Special Bulletin

SP16-311G

DIRECT LIGHT COVER LENS SECUREMENT

Prevost vehicles

Figure 1: Curb side lenses. "A" 4ft lenses: follow instructions

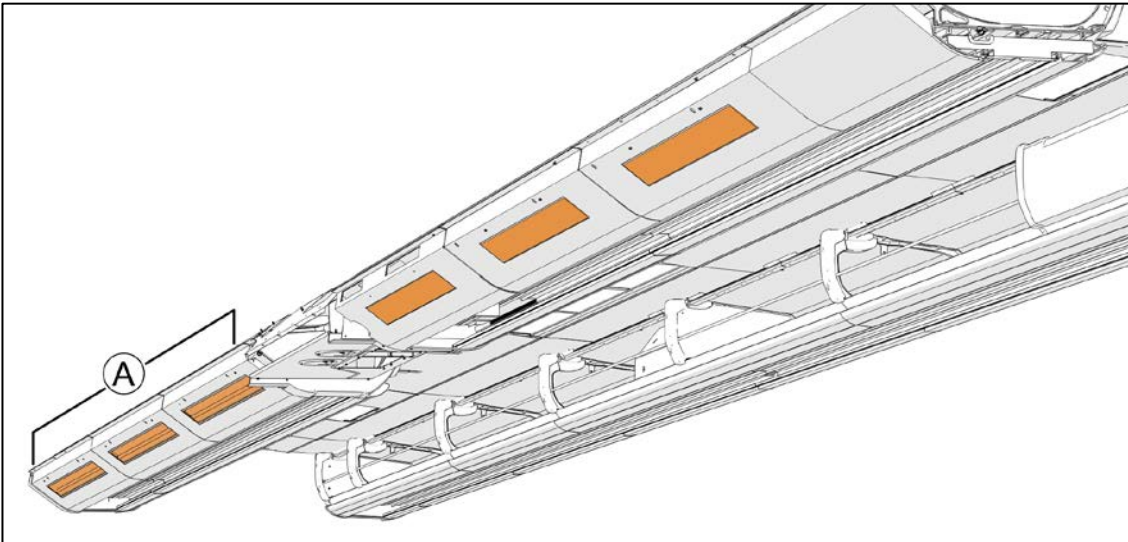
3. Refer to Figure 1 and Figure 2. If lens is longer type "A" it needs to have the "U" shape edge on the bottom of the opening and the rolled edge at the top

9. Refer to Figure 1 and Figure 2. Type "A" lenses are longer and need an additional clip along the outer edge (window side) at mid length (24" from front edge of lens)

Figure 3: Simple Templates

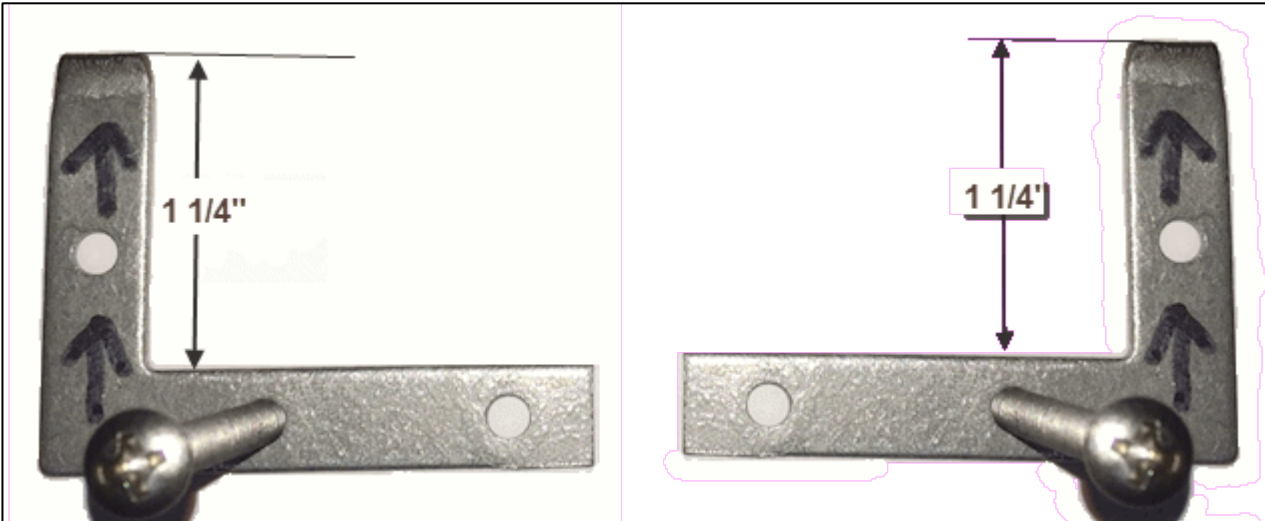
1. Before starting any work, protect the passenger seats under the lens by installing a clean drape to collect debris from drilling and bulletin activities.
2. Fabricate a set of two simple templates (Figure 3) to locate the Z-supports 1 1/4" from the edge of the lens. (Figure 4)

Figure 4

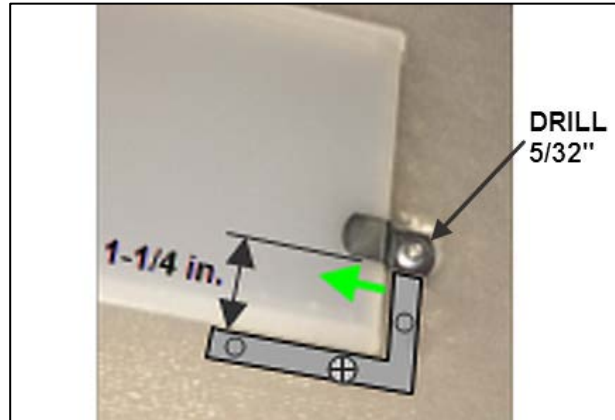
4. Position the template as shown in Figure 4 and place a small mark on the lens at the top of the vertical leg.
5. Align the Z support with the mark on the lens and push the support against the lens.
6. Drill 5/32" hole. (Figure 4)

Remove the 4th lens from the front of the vehicle, street side *before drilling* to avoid any interference with hoses in this location.

Figure 6: 3rd clip on type "A" lens

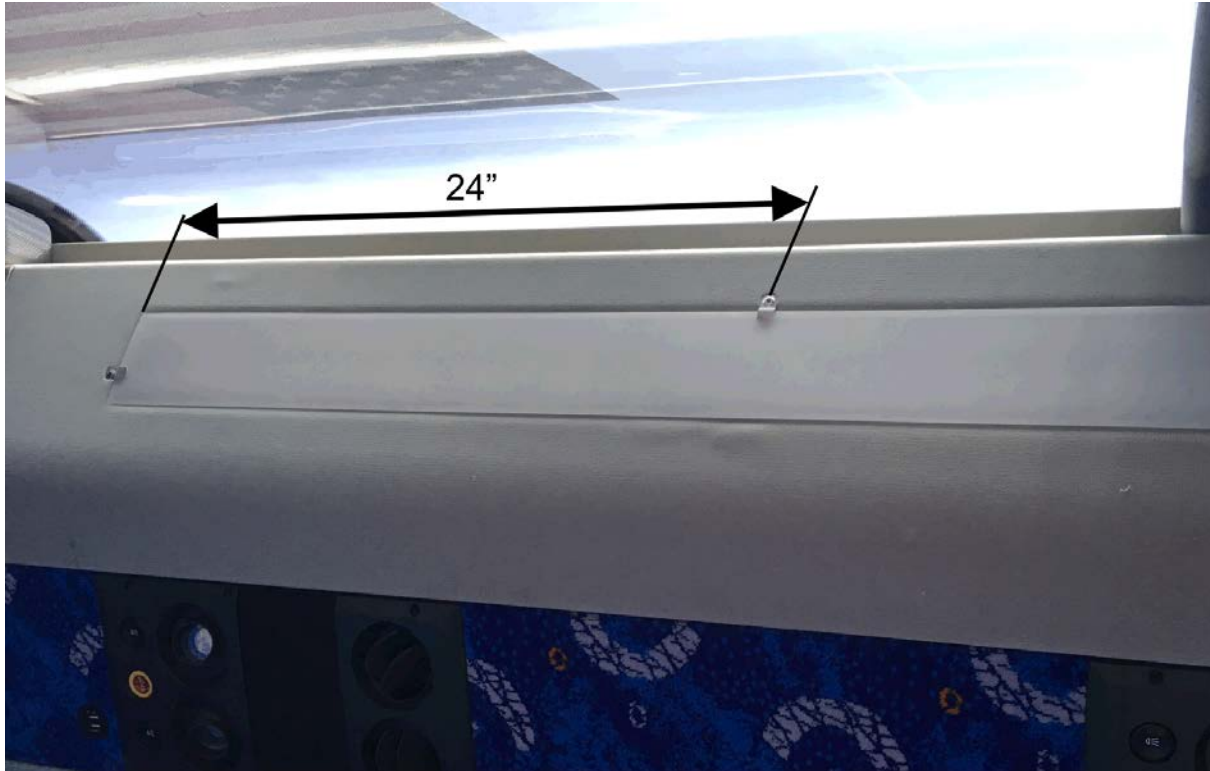
10. Place the Z-clip against the lens and mark hole location.
11. Drill 5/32" hole.
12. Rivet Z support in place with 504247 rivet
